**Planning Department
Transportation Development Services Section**

Re: Certification Submittal for a Permanent Building Certificate of Occupancy (C.O.)
for Beauty College / Rt. 66 Malt Shop and Grill, [K-17/ D104]
3800 Central SE
Engineer's Stamp Dated 08/27/10

Re: Beauty College Parking / Route 66 Malt Shop and Grill, 3800 Central Ave SE,
Traffic Circulation Layout
Architect's Stamp dated 03-15-10 (K17-D104)

DRIVEPAD PLAN

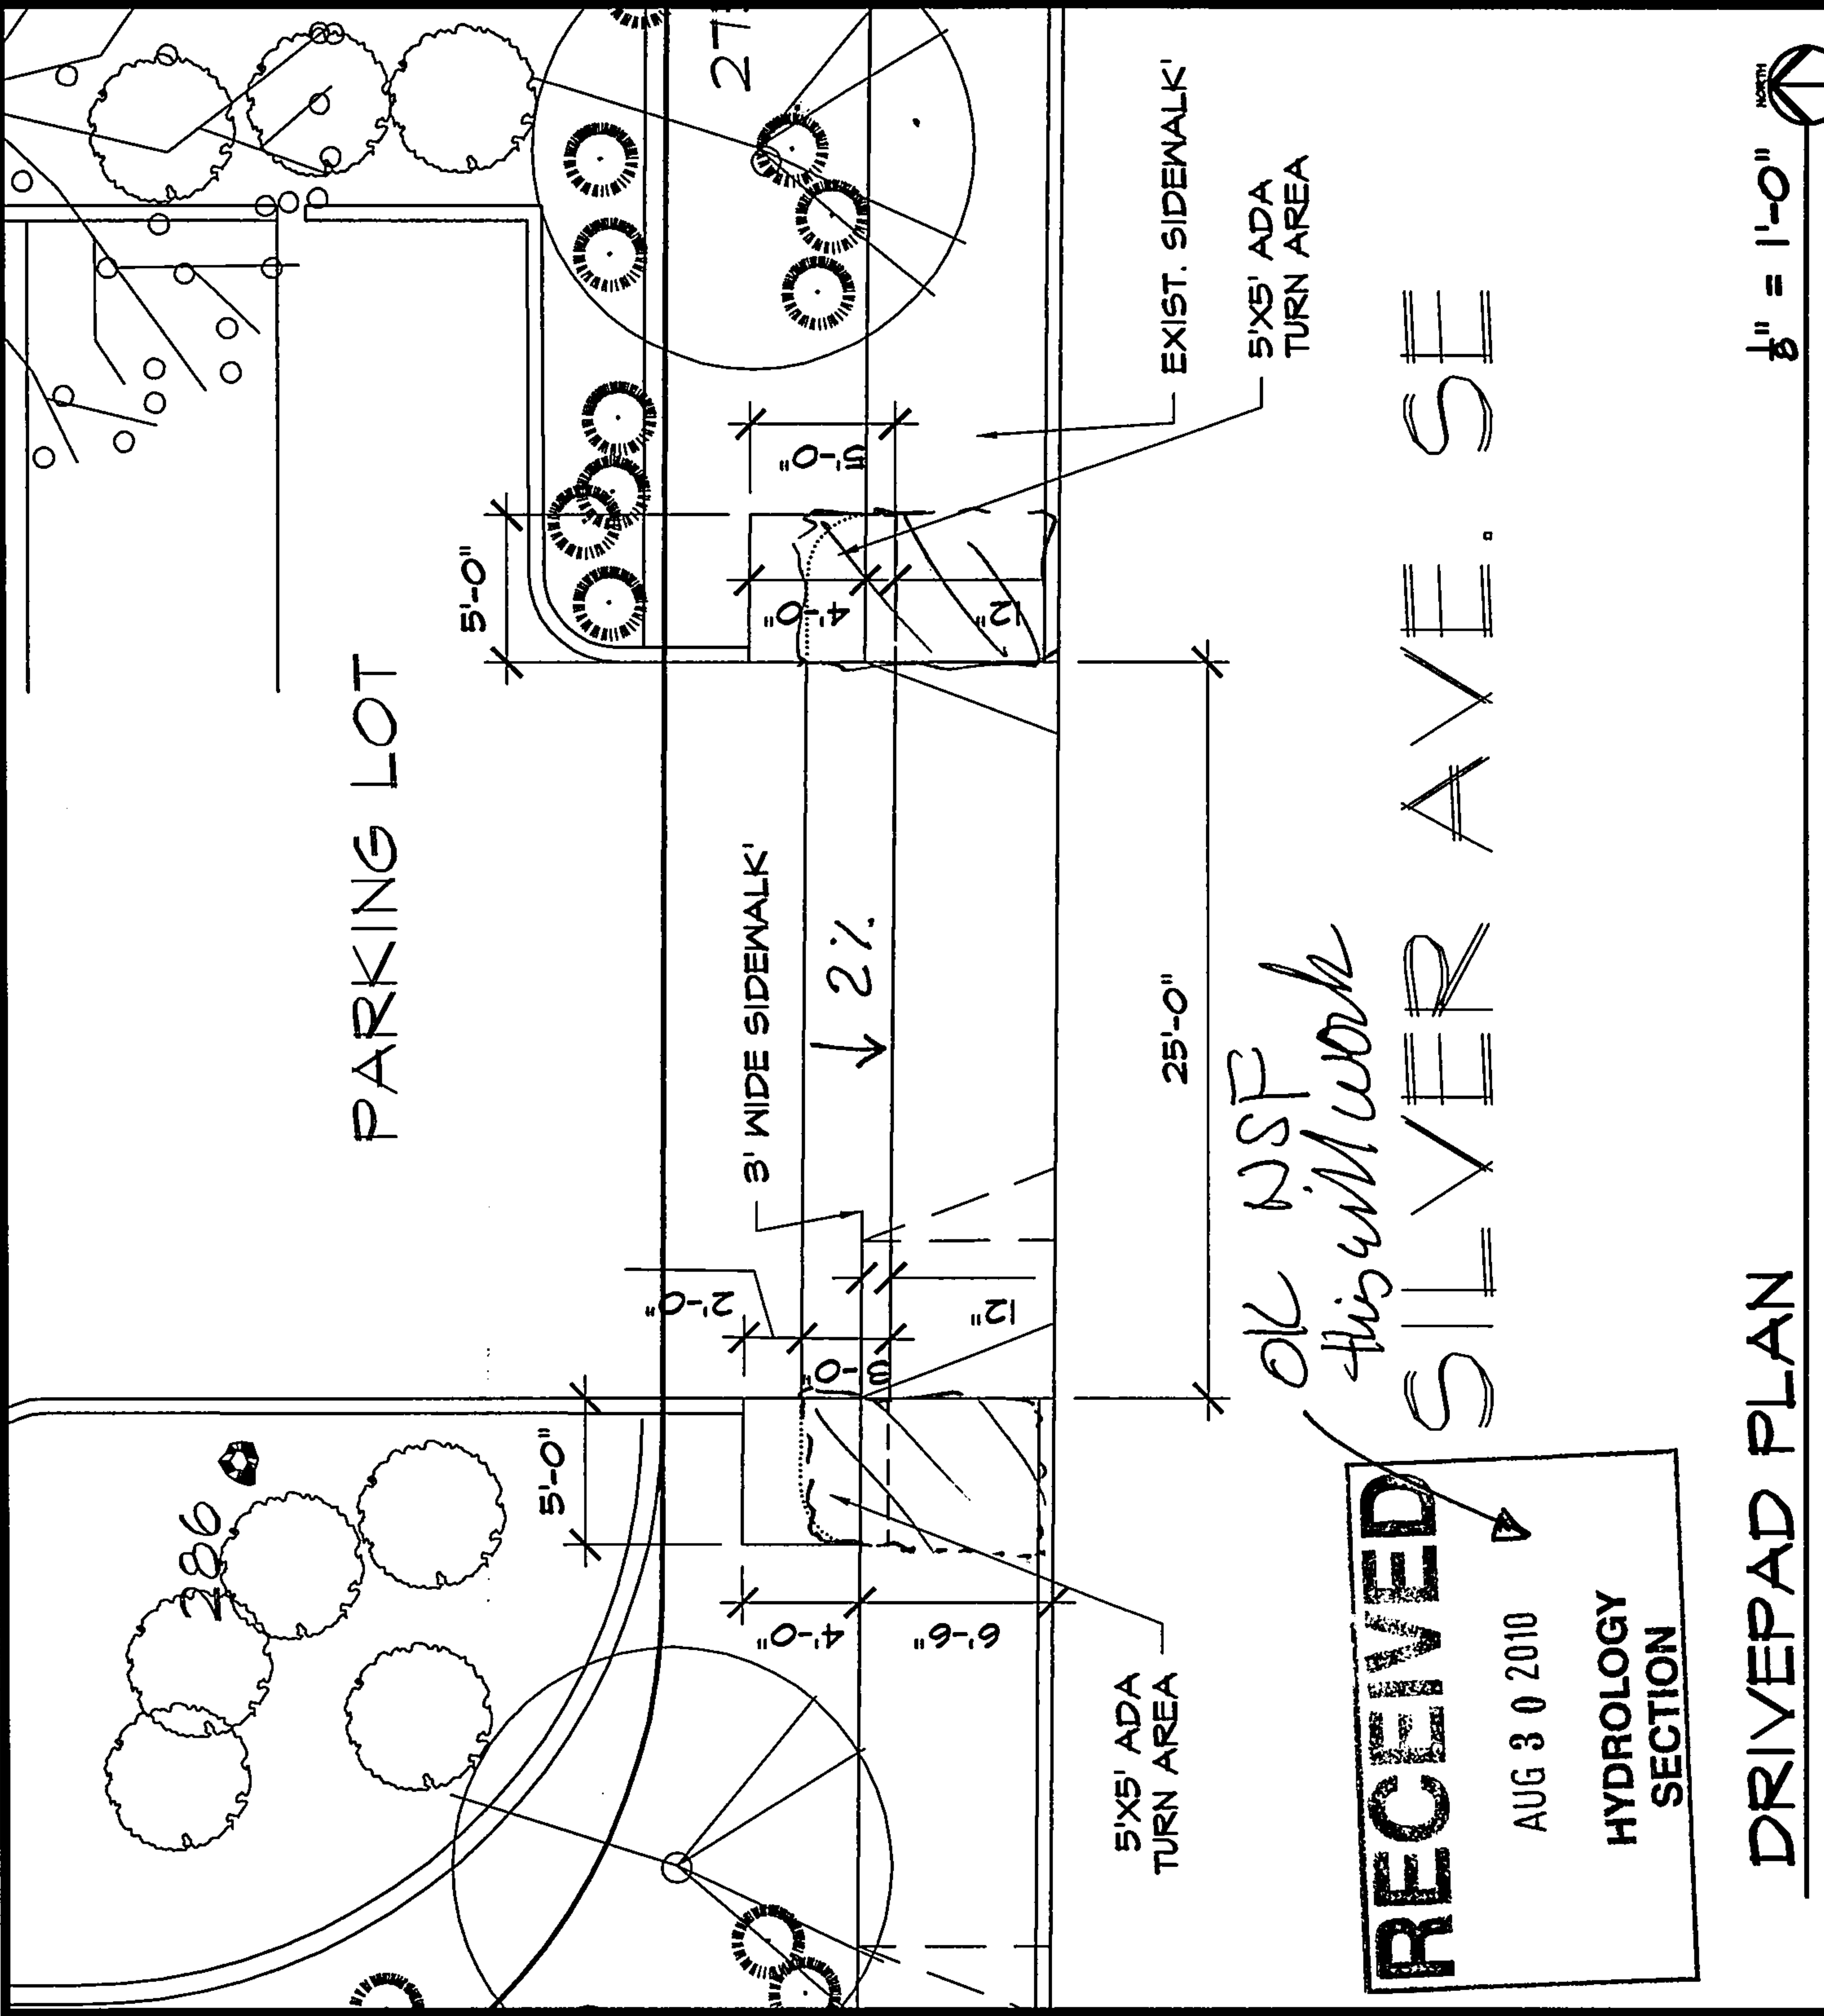
*OK WSF
 this will work*
 SILVER AVE. SE

Based upon the information provided in your submittal received 08-27-10 and the exhibit provided on 08/30/10 (drivepad modification exhibit), Transportation Development has no objection to the issuance of a Permanent Certificate of Occupancy. This letter serves as a "green tag" from Transportation Development for a Permanent Certificate of Occupancy to be issued by the Building and Safety Division.
